Sub: 73वीं पी.सी.सी बैठक का कार्यवृत Minutes of 73rd PCC Meeting.

73rd Protection Coordination Sub-Committee Meeting

Date: 26/11/2024 (Tuesday)

B.9 Grid Disturbance in Karong area of Manipur on 13-10-2024:

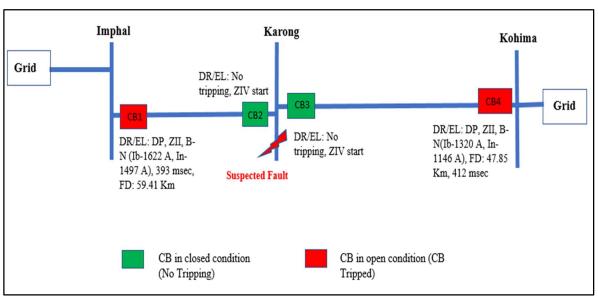
- B-N fault initiated at 23:36 Hrs & cleared within 412 msec from Kohima end and within 393 msec from Imphal end on operation of DP, ZII. There was no tripping from Karong end. ZIV started for both 132 kV Imphal-Karong line & 132 kV Karong-Kohima line.
- Suspected fault is in 132 kV Karong Bus /downstream feeder which was cleared by tripping of 132 kV Imphal-Karong line and 132 kV Karong-Kohima line from remote ends.
- Time drift of 2 min observed at Imphal end for 132 kV Imphal-Karong line which need to be sync with GPS by MSPCL.

MSPCL is requested to update the root cause of the event and remedial measures taken.

Forum decided that the matter to be taken up separately by NERPC with concerned officials of Manipur. Also, Forum suggested that protection audit needs to be conducted in Karong S/S.

B.10 Grid Disturbance in the Imphal (Yurembam) substation of Manipur power system on 28th October 2024:

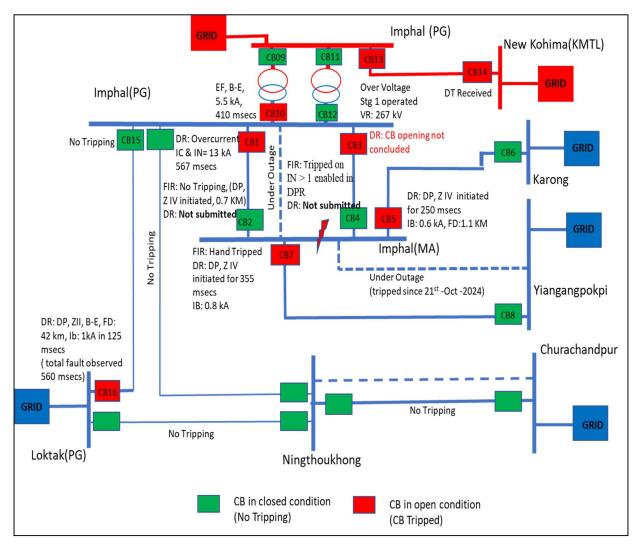
As informed by MSPCL, B-phase Bus jumper snapped at Yurembam S/S. Major Protection issues observed are as follows:

- 1. 132 kV Imphal(PG)- Imphal(Yurembam) 1 Line tripped on Overcurrent at Imphal(PG) end in 567 msecs. However, the same was not detected by the Main Relay. To be checked by NERTS.
- 2. 315 MVA ICT I at Imphal(PG) tripped at 132 kV side on Backup E/F in 410 msecs on reverse fault. Directionality of the LV side backup relay need to be rectified by NERTS.
- 3. High Voltage of Vre: 267 kV observed in the Imphal(PG) end of the 400 kV Imphal(PG) New Kohima 1 Line after the tripping of Tie CB of 315 MVA, ICT-

1 which resulted into the tripping of the line. NERTS is requested to check & rectify the reason for HV in the R-Phase of 400 kV Imphal(PG) - New Kohima 1 Line.

- 4. 132 kV Imphal (PG) Loktak Line detected the fault in ZIII for 420 msecs & then ZII initiated and tripped the CB in next 125 msecs. However, ZII time delay need to be reviewed by NHPC.
- 5. Tripping of 132 kV Imphal (Yurembam) Yaingangpokpi 1 Line, 132 kV Imphal (MSPCL) Karong Line and 132 kV Imphal(PG)- Imphal(Yurembam) 3 Lines could not be concluded due to non-availability of the DR & EL of Yaingangpokpi, Karong and Imphal (Yurembam) end. MSPCL is requested to share the DR & EL files.
- 6. DR time synch Issue observed in the submitted DR for CB3 and CB7. MSPCL is requested to rectify the same for proper analysis purpose.

MSPCL is requested to share the actual reason for the GD at Imphal (Yurembam) and its corrective measures taken.

- 1. Manipur stated, regarding the root cause of the fault, that fault initiated due to B-phase Bus jumper snapping at Yurembam SS, however further investigation are underway to ascertain the correct root cause of the fault.

- 2. NERTS informed that for 132 kV Imphal(PG)-Imphal(Yurembam) III line, Bay at Imphal(PG) owned by MSPCL and relay did not sense any fault during the event.

- 3. 132 kV Imphal(PG)- Imphal(Yurembam) 1 Line tripped on Overcurrent at Imphal(PG) end in 567 msecs. NERTS informed that distance relay sensed the fault in ZIII.

- 4. NERTS informed there was some wiring issue in 315 MVA ICT-I at Imphal which has been rectified.
- 5. NERTS informed O/V at Imphal(PG) was caused in 400 kV Imphal-New Kohima I line during switching of PT selection relays during trip of ICT-1 in which contact of PT selection relay was found burnt & continuously shorted. The same has been replaced.

7. The forum opined that the incident involves multiple failure of protection system at connecting substations and lines and therefore referred the matter to PSAG for further analysis and finalization of remedial actions.

B.11 Grid Disturbance in Dibrugarh area in Assam on 29-10-2024:

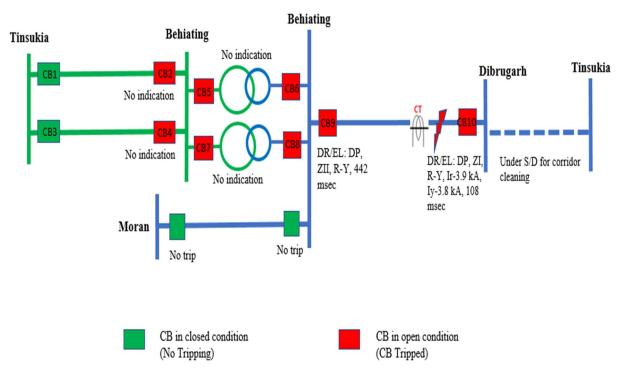
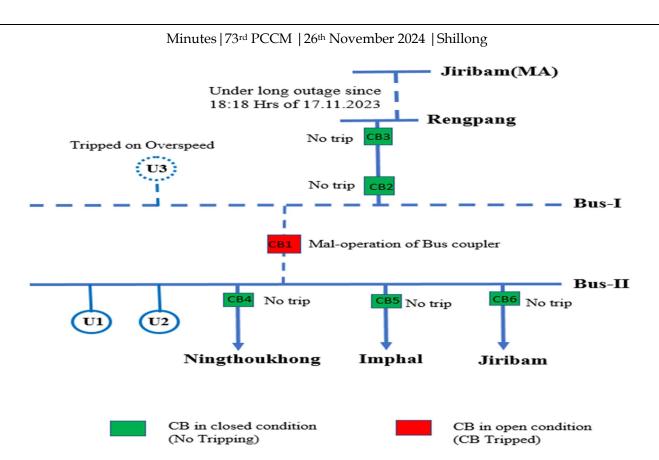
- 220 kV Behiating-Tinsukia I & II lines tripped from Behiating end within 265 msec of inception of fault. It is unclear which protection system operated at Behiating.
- 2. 220/132 kV Behiating ICT-I&II tripped. As per EL, O/C started at 09:05:53.386 Hrs. HV side CB open at 09:05:53.600 Hrs.
- 3. Tripping of upstream 220 kV Behiating-Tinsukia D/C lines & 220/132 kV Behiating ICT-I&II for fault in 132 kV Dibrugarh-Behiating line seems to be unwanted.

AEGCL is requested to update the findings and review the protection setting of 220 kV Behiating-Tinsukia D/C lines & 220/132 kV ICT-I&II at Behiating to prevent further re-occurrence of such events.

- 1. AEGCL informed that fault is between CT and Line Isolator (RØ-YØ) of 132 kV Dibrugarh Behiating Line.
- 2. AEGCL informed that O&M of Behiating substation is under NERPSIP and as per the NERPSIP team, LBB logic was fulfilled in 220 kV Behiating-Tinsukia I line due to master trip operated signal high intentionally in the logic and LBB protection operated at 220 kV Behiating due to which 220 kV Behiating-Tinsukia I & II lines and 220/132 kV Behiating ICT-I&II tripped. He further informed that the issue of master trip high has been resolved by NERPSIP.
- 3. NERLDC highlighted the absence of Carrier inter-trip scheme in 132 kV Dibrugarh-Behiating line. The same needs to be reviewed by AEGCL.
- 4. Forum asked AEGCL to review the protection setting at Behiating S/S thoroughly.

B.15 Tripping of 132 kV Karong-Kohima line & 132 kV Kohima- Zadima line on 02-Nov-2024:

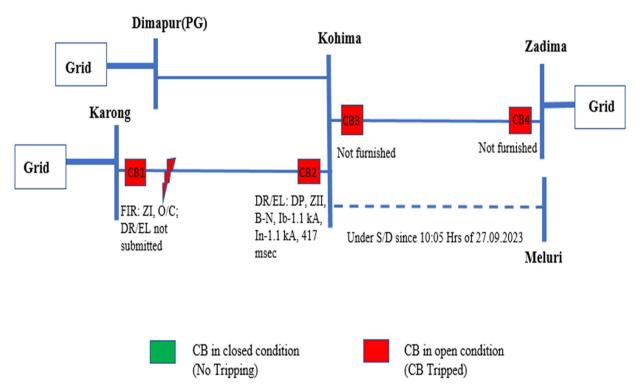
As per FIR, submitted by MSPCL, tripping occurred at Karong end on operation of OC, ZI.

The forum strongly urged DoP Nagaland and MSPCL to provide the required data to NERLDC at the earliest. Forum also opined that the B/U protection settings at Zadima end need to be revised and asked DoP Nagaland to revise the same in coordination with NERPSIP under guidance of NERPC and NERLDC.

C.4 Grid Disturbance in Mokokchung(NL) and Longnak areas of Nagaland power system on 07-09-2024:

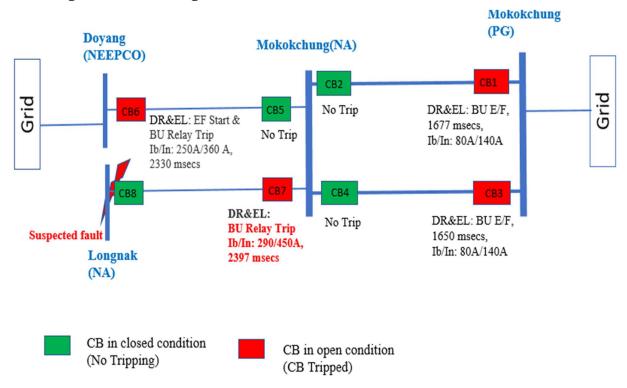
- i. The transformer differential protection should have isolated the fault and requested DoP Nagaland to check the protection system of the ICT
- ii. There was delayed operation of the B/U protection at Mokokchung(NA) and requested Nagaland to revise the settings in coordination with NERPC and NERLDC
- iii. B/U protection at Doyang should have operated faster than that at Mokokchung (PG) as the fault current was higher and requested NEEPCO, PGCIL to coordinate the settings.

Regarding coordination of B/U protection at Mokokchung(PG) and Doyang substations, the forum directed PGCIL and NEEPCO take necessary actions at the earliest.

C.5 Tripping of 132 kV Aizawl-Tipaimukh line on 30th August, 2024

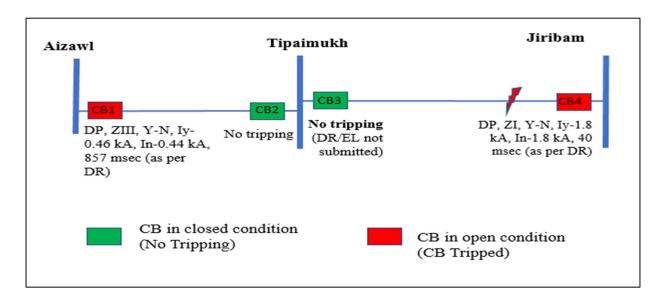
As per DR analysis, Y-N fault in 132 kV Jiribam-Tipaimukh line cleared within 40 msec from Jiribam end on operation of DP, ZI. Carrier signal was sent to Tipaimukh end from Jiribam. However, CB at Tipaimukh end did not trip until 800 msec from inception of fault which led to clearing of fault by tripping of healthy 132 kV Aizawl-Tipaimukh line from Aizawl end on operation of DP, ZIII within 857 msec.

In 71st PCCM, Manipur representative informed that checking by local staffs was done recently but expert visit was required. He further informed the forum that due to landslide issue road was not approachable for them to send any skilled staff to Tipaimukh SS to download DR/EL for the event for further analysis and submission to NERLDC. He further stated that access to Tipaimukh was through Aizawl only. Therefore, Manipur requested the forum to provide support either from Mizoram or NERTS.

Forum requested Mizoram & NERTS to provide necessary support to Manipur at earliest.

Mizoram and PGCIL informed that no request from Manipur has been initiated for MSPCL side for support in accessing the site. The forum asked MSPCL to initiate the necessary communication in this regard.

C.6 Grid Disturbance in AGTCCPP generating station of NEEPCO on 12-09-2024:

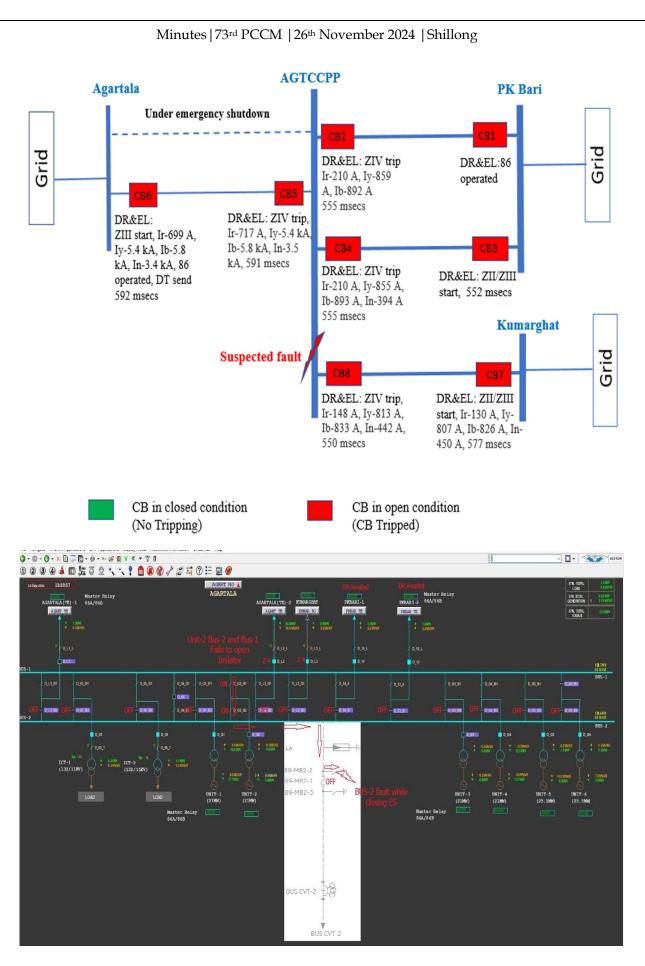
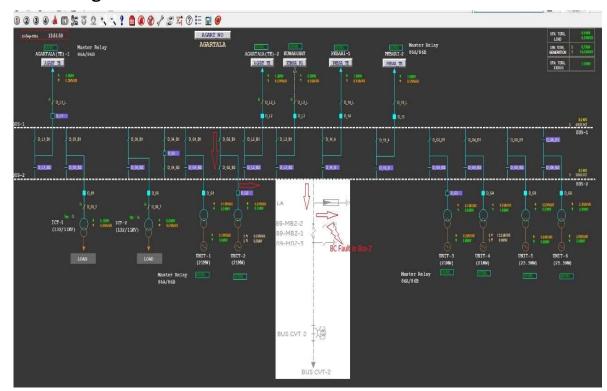
At 13:43 Hrs of 12-09-2024, 132 kV AGTCCPP - Kumarghat Line, 132 kV Agartala - AGTCCPP 2 Line and 132 kV AGTCCPP - P K Bari D/C lines tripped due to which AGTCCPP generating station of Tripura power system was blackout due to loss of evacuation path.
